RECALL BULLETIN:
101105FRV

Terra, built 6/24/2010 through 10/4/2010

MODEL(S) AFFECTED:
31TS, 34DS

SUBJECT:
Inspection/Correction of high-beam and low-beam headlights

Figure 5 - View shown from inside of lower front cap

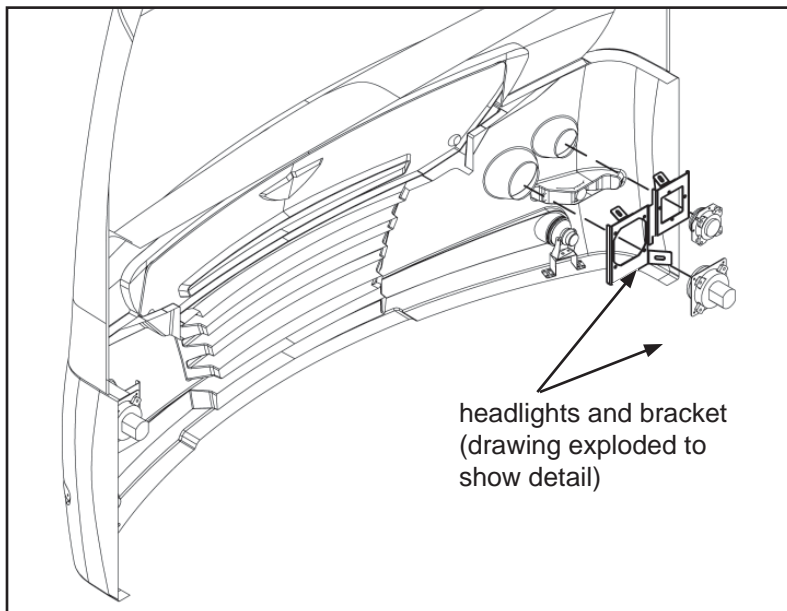
- Label and then remove the battery cables from the Main chassis battery, located on the front of the bulkhead, and the Auxiliary batteries, located under the entry step. Remove the battery negative cable first, and then remove the positive cable.
- Open the engine compartment door to access the headlights. **VERIFY** there is no power to the headlights. Cut the wires for each headlight where the chassis wire harness connects to the headlight wire harness. Label the chassis wire harness connections (e.g., "HI" and "LO") if no labels are present.
- Locate the two brackets securing the headlights to the studs inside of the lower front cap. (See Figures 5 and 6.) Use an inspection mirror if necessary to locate and remove the fastening hardware for the brackets, then remove the brackets using a driver with socket bit, or a ratchet. Retain brackets and fastening hardware for reassembly.

Figure 6 - Headlights and bracket assembled inside of front cap

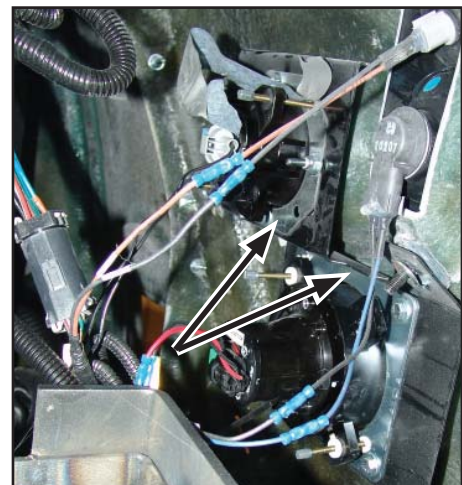
8. Plug the headlight wire harnesses (included with each new headlight) into the back of the new lights.
9. Position the headlight assembly inside the lower front cap and reinstall the bracket onto the studs in the cap using original fastening hardware. Torque nuts to 40-45 inch-lbs.
